| SKIPPER DATA BULLETIN | | Number: | SDB_DL850_17 |
| DL850S-SB sensor wrong forward direction mark | | | |

DL850S-SB. Log sensor for ETNSLB Sea Valve DL850 540kHz Flat.

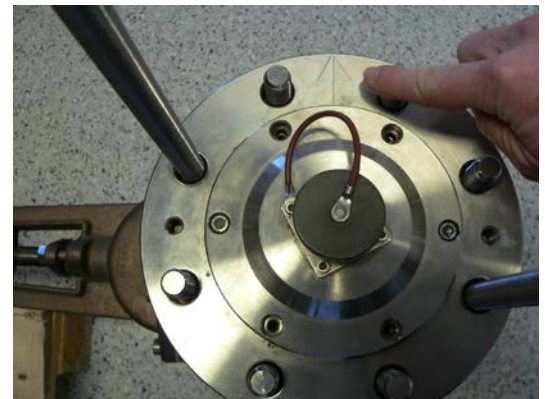
The first batch of the new sensor 540kHz DL850S-SB was manufactured with forward arrow pointing 180 deg wrong.

Serial numbers: 13125 to 13136.

Mount the whole transducer rotated 180 degrees.

(Forward arrow pointing aft)

Make sure a note is written on a sticker on the sensor in case the sensor is later lifted for inspection or cleaning.

“Screen Calibration”, “Menu3”

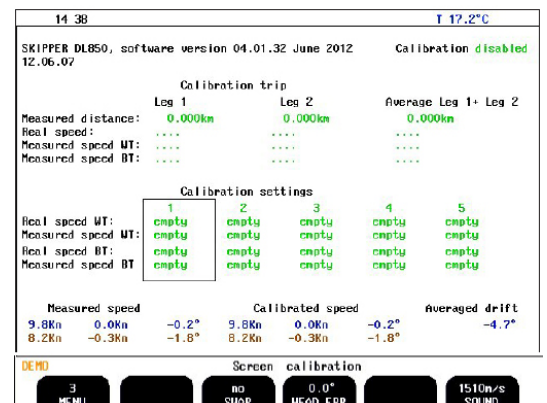
If the sensor is already installed the user can

electronically rotate the transducer in

Enable calibration with “hidden button” set “SWAP F-A, P-S”
